SCHEDULE A: Applications with Recommendation

Location: Former KSS Factory Site, Constable Street, Carlisle, CA2 6AQ

Proposal: Variation Of Condition 2 (Approved Documents) And Removal Of Condition 13 (Emergency Vehicle Access) Of Previously Approved Application 18/0125 (Erection Of 43no. Dwellings) To Amend The Site Layout To Allow Units 12-31 (Inclusive) To Use The Adopted Highway East Of The Site (Retrospective Application)

Stage 3 Road Safety Audit

Location: The speed hump at the entrance to Carrick Square.

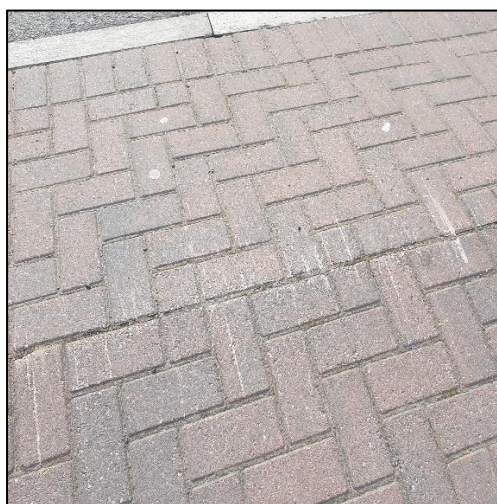
Summary: The absence of road markings could increase the risk of loss of control collisions.

There is evidence of vehicles grounding on the speed hump, but there are no shark's tooth markings on the ramps or warning signs present. In their absence, drivers and riders could fail to identify the hump, strike it at speed or brake suddenly and lose control.

It is recommended that road markings to Diagram 1062 are installed on the speed hump, and a sign to Diagram 557.1 provided, together with an appropriate supplementary plate.

Location: The junction of Blunt Street with Leicester Street.

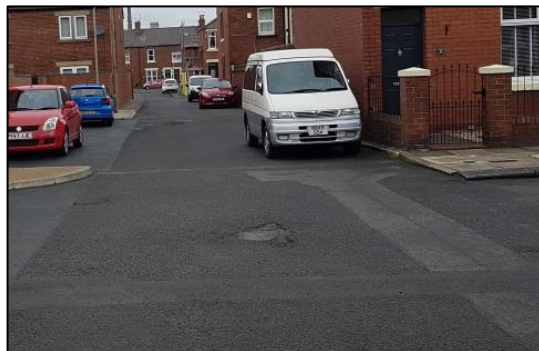
Summary: The condition of the carriageway could increase the risk of collisions.

While perhaps a routine maintenance issue, the carriageway is patchy, broken out and worn in places. Motorists and two-wheelers could strike the damaged areas, with the risk of loss of control and of collisions. There is one area that has been plucked out that could further deteriorate, retain water and freeze, with the attendant risk of skidding collisions.

It is recommended that the damaged areas are repaired.
